DocNum: T10/01-057r0  
Date: 2001/01/23  
Author: Eric Anderson (ewa@apple.com)  
Title: **Proposal for Fast Start in SBP-3**

#### **5.4 Fast Start packet**

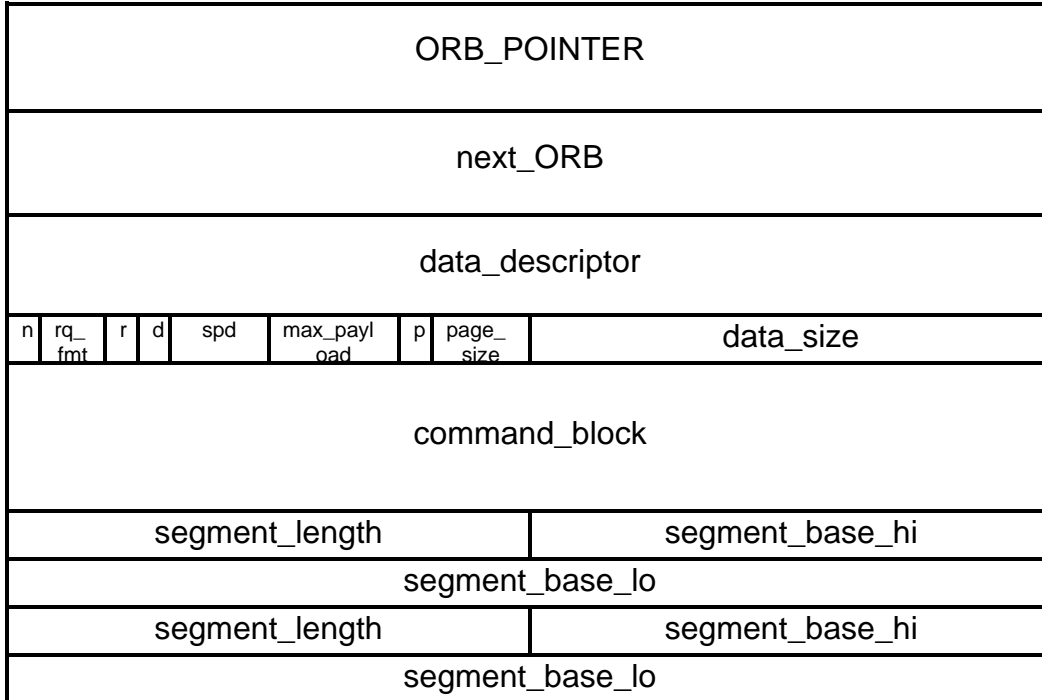
The Fast Start packet is formed by concatenating three SBP data structures defined elsewhere in this document: An ORB\_POINTER (see 6.4.3), an ORB (see 5.1), and (optionally) a page table (see 5.2). The Fast Start packet is assembled by the initiator and sent to the target using a Serial Bus block write transaction.

The target needs an ORB\_POINTER so that it can report status as defined in section 5.3, even though the entire ORB is included in the Fast Start packet. The ORB\_POINTER may also be read by the initiator as described in section 6.4.3. The ORB included in the Fast Start packet shall exist in initiator memory at the address indicated by ORB\_POINTER.

If an ORB does not reference a page table, no page table is included in a Fast Start packet for that ORB. The page table included in a Fast Start packet (if any) shall exist at the address indicated by data\_descriptor.

The following figure shows an example of a Fast Start packet for an ORB that includes 12 bytes of command\_block and references a small page table.
